MINERALS PROGRAM INSPECTION REPORT
PHONE: (303) 866-3567

MINE NAME: T Bone Stone Quarry	MINE/PROSPECTING ID#: M-2004-030	MINERAL: Stone	COUNTY: Boulder
INSPECTION TYPE: Monitoring	INSPECTOR(S): Amy Eschberger	INSP. DATE: May 17, 2017	INSP. TIME: 12:30
OPERATOR: T Bone Stone, Inc.	OPERATOR REPRESENTATIVE: Bill Tenore	TYPE OF OPERATION: 110c - Construction Limited Impact	
REASON FOR INSPECTION: Normal I&E Program	BOND CALCULATION TYPE: Partial Bond	BOND AMOUNT: \$68,574.00	
DATE OF COMPLAINT: NA	POST INSP. CONTACTS: None	JOINT INSP. AGENCY: None	
WEATHER: Clear	INSPECTOR'S SIGNATURE: 	SIGNATURE DATE: June 7, 2017

M-2004-030 / T Bone Stone Quarry / T Bone Stone, Inc.

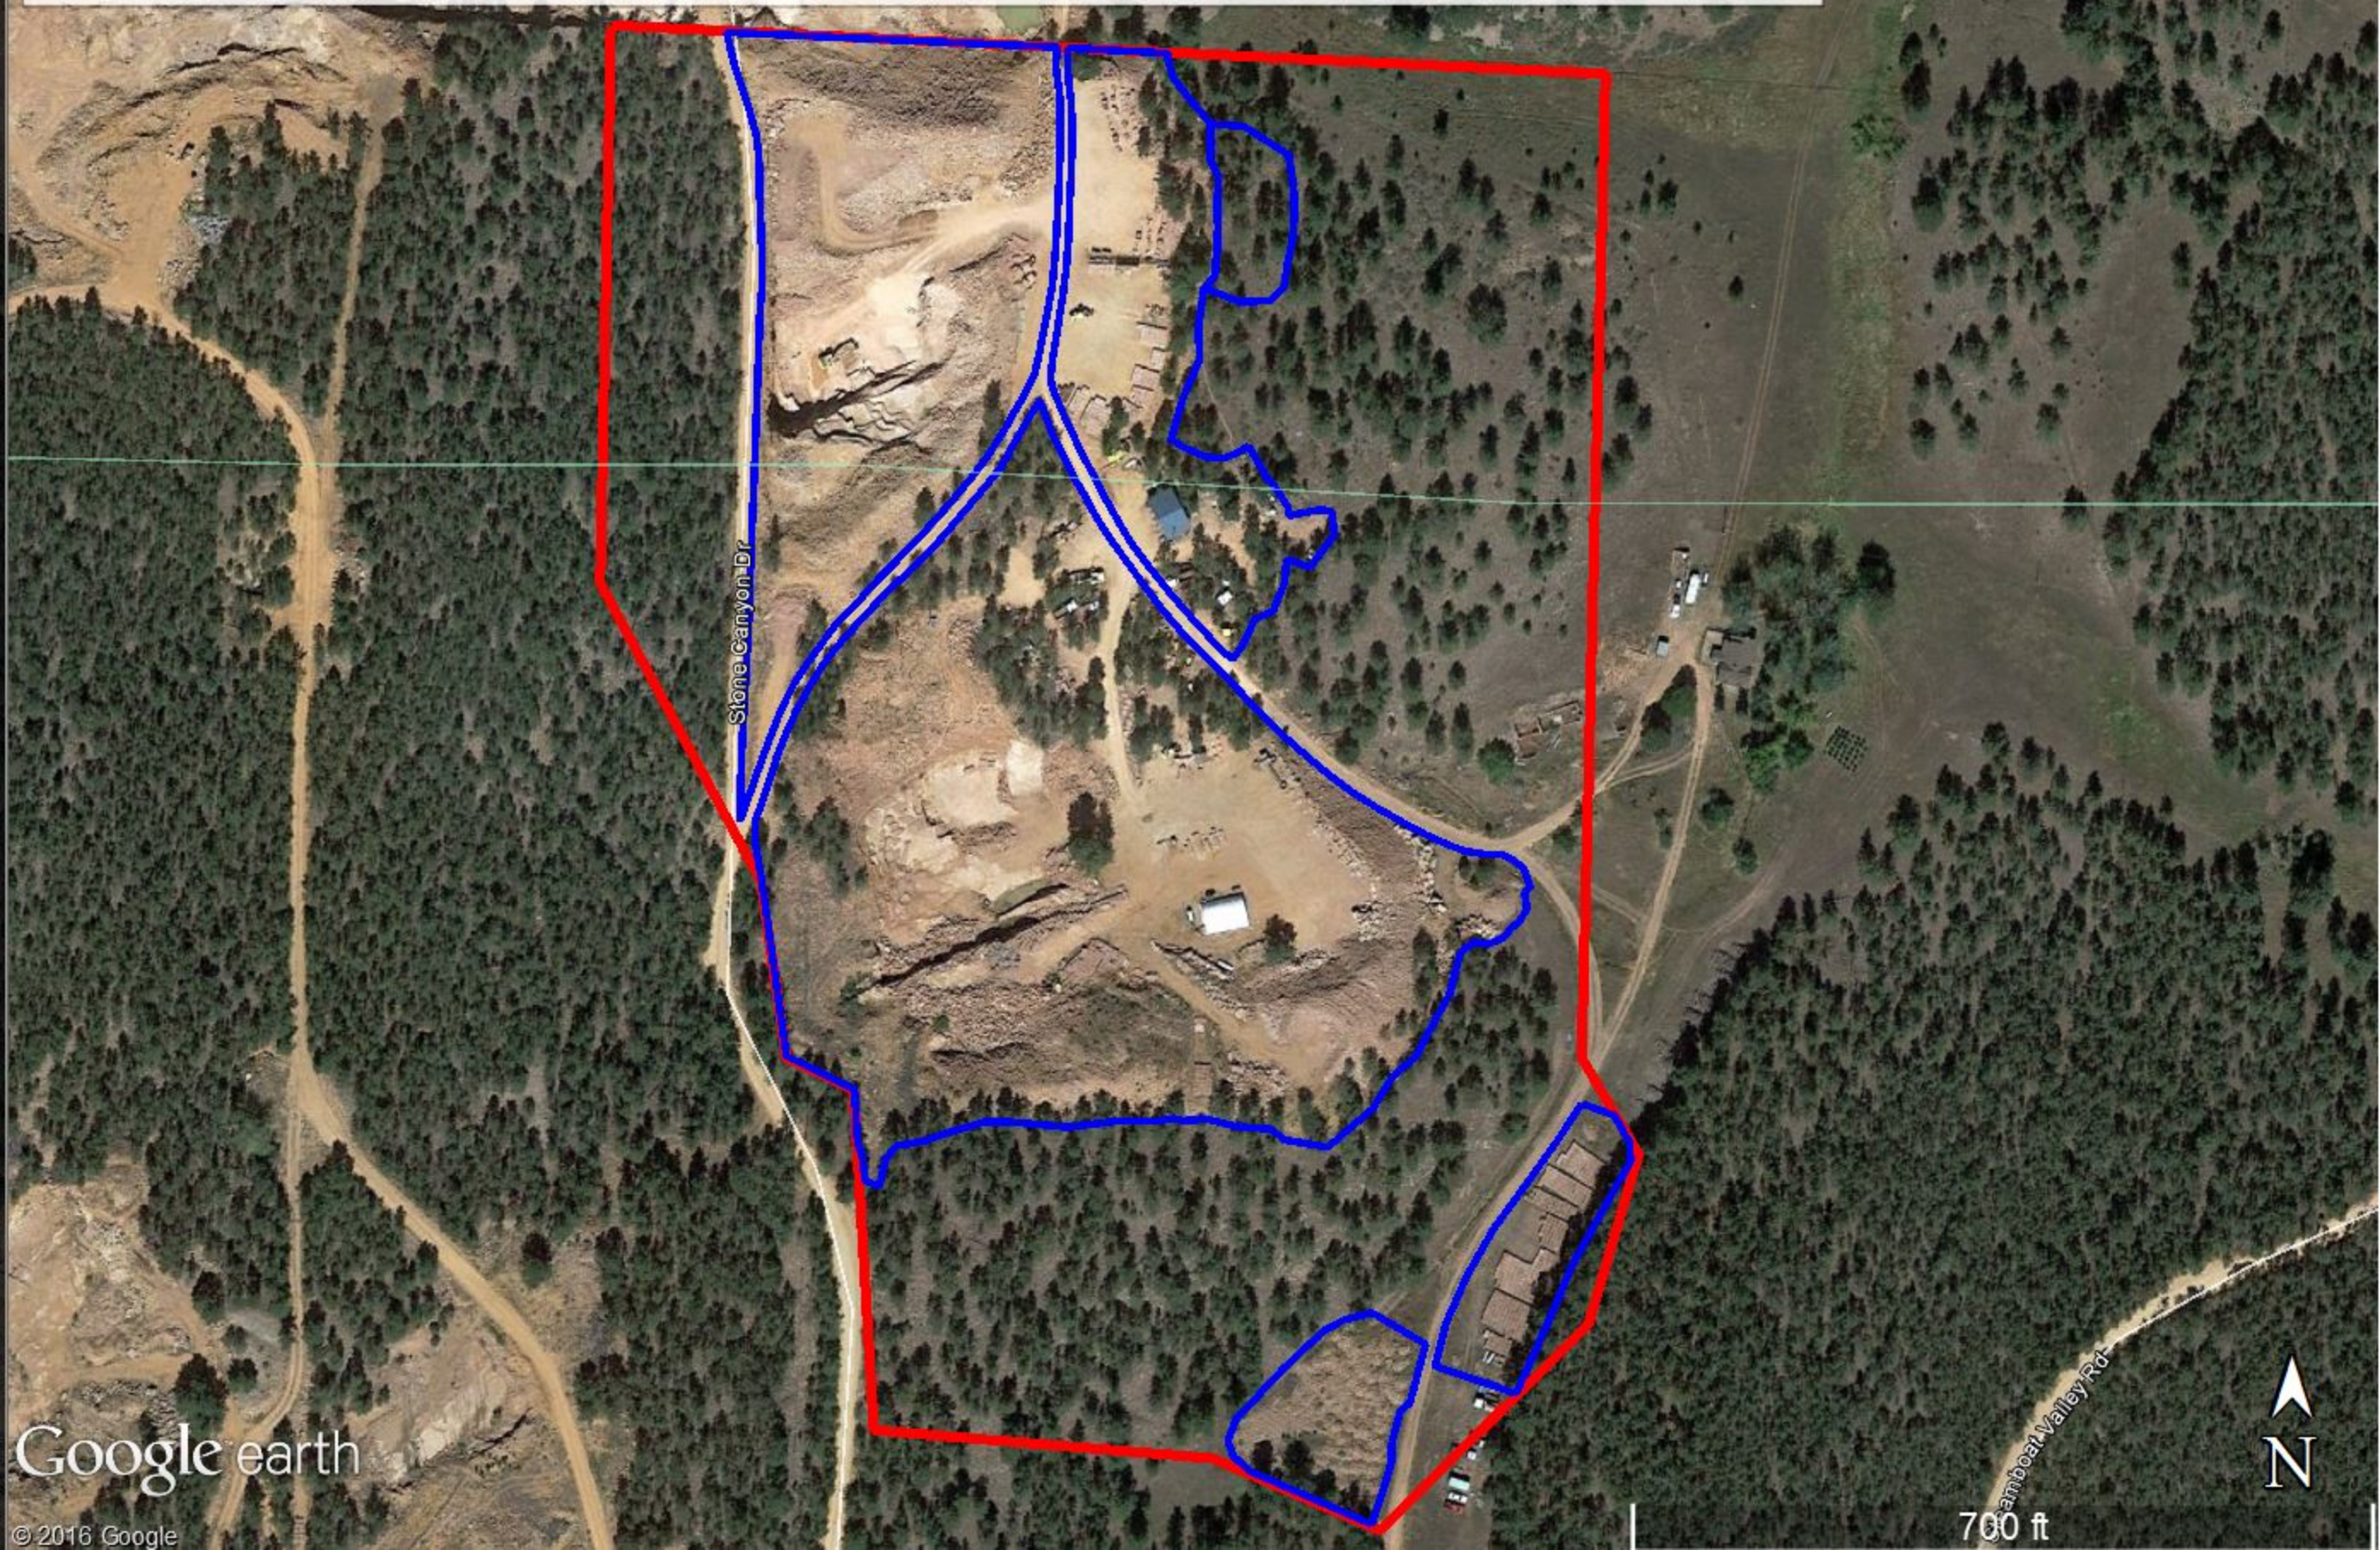
Since the date of the last aerial image available in Google Earth (9/7/2016), the operation has begun opening up the area located east of the loading and storage area in the northern portion of the site (**Photos 7 and 8**). The Division estimates this disturbance to be approximately 0.25 acre in size. This area is included in the total disturbed acreage amount and approximated on the enclosed Google Earth image of the site. Disturbance on site also includes an equipment and fuel storage area located adjacent to the haul road that connects the two quarries (**Photos 9 and 10**). The Division observed that fuel storage tanks were properly bermed for secondary containment.

The operation appears to be following the approved mining and reclamation plans. More than enough overburden is available on site for backfilling the quarries, with little to no haul distances. According to the approved mining plan, the quarries could be mined deeper. It should be noted the current disturbance amount of 12.75 acres is only 1.75 acres short of the approved maximum allowed disturbance of 14.5 acres. In expanding the operation eastward, the operation should be very careful not to exceed the maximum disturbance amount for which the Division currently holds a bond. If the operator intends to disturb more than 14.5 acres, a Technical Revision will need to be submitted to increase the maximum allowed disturbed area to more than 14.5 acres (see enclosed form). In review of the Technical Revision, the Division would recalculate the required financial warranty for the proposed increase in disturbance.
